**Flood Control Project Maintenance  
Levee Inspections**

**Maintenance Issue Types Only, Levee Inspection Report By Mile - Fall 2022**

**Reclamation District No. 0999 Netherlands**

Photo 3 of 3 : UCIP\_FA\_2022\_73776\_88524.jpg

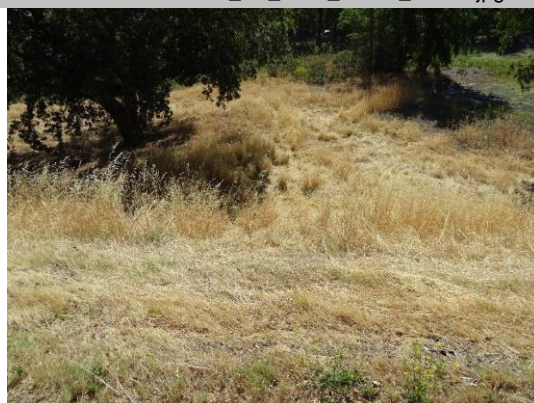
Comment Code						
Inspector Comment						
DS_ID:22743 FS_ID:73776 EP_NO: N/A Repair Type: Urgent EVAL Issue: 1, Pipe Integrity Crossing Status: Found UCIP Comments: 06/16/2020 Record remains Non-Urgent. Crossing appears abandoned. Recommend owner to contact CVFPB to abandon or remove pipe from levee. System Feature. (D.Sanoski - DWR UCIP) 07/26/2018 Same as last inspection. Pipe open on WS, but no visual signs of pipe or levee integrity issues so downgrading crossing to Non-Urgent (D. Sanoski - DWR UCIP).07/07/2016 Condition largely unchanged from previous inspection. Pipe open on the WS, waterward of the siphon breaker. Dense vegetation and steep slope limited inspection of WS outlet into Ship Channel. (T. Hatch/UCIP)06/25/2013 Pipe abandoned and open on WS slope. Pipe should be abandoned properly. (W. Wylie/UCIP) FIELD_STRUCT_DESC: 30-inch steel drainage pipe through the levee, 6.5 feet below the crown. Pump on a platform in the canal off the landside (LS) toe. Flap gate on the waterside (WS). Siphon breaker and an air vent on the WS shoulder. 1-inch galvanized iron filler pipe visible on the WS shoulder along same alignment. [Additional Reference(s): DWR Levee Log, 1992 (HLM 1.73). USACE Sacramento O&M Manual, Unit 113, October 1966, Revised 29 December 2016, (1.73), listed as 30-inch pipe]. FS Date: 6/16/2020 2:16:00 PM

Land-Side: view of LS slope and pump platform off in distance.

Photo 1 of 1 : FA\_2022\_RD0999\_236\_273\_20220822\_00096.jpg

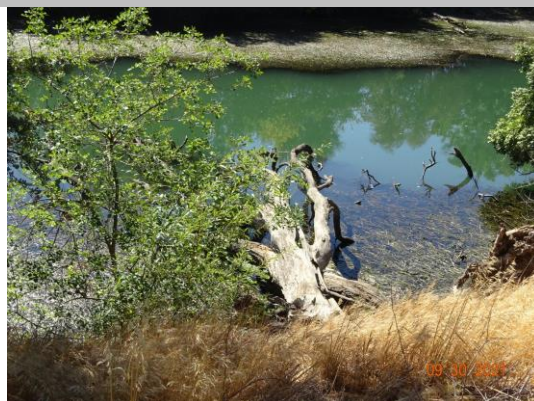
LM Start	1.17	Rating **	M	Issue No.	273
LM End	1.17	Issue Type +	Ma	Location *	WS
Category	Earthen Levee			GPS Latitude/Longitude	
				Start	End
Item	Trim / Thin Trees			38.348307 °	38.348307 °
				-121.578045 °	-121.578045 °
DWR ID	DWR_RD0999_05_f_2021_273				
Comment Code					
T3 : Fallen tree with root ball.					
Inspector Comment					
Remove the large tree debris on the waterside slope,

Fallen tree in channel. Fall 2021
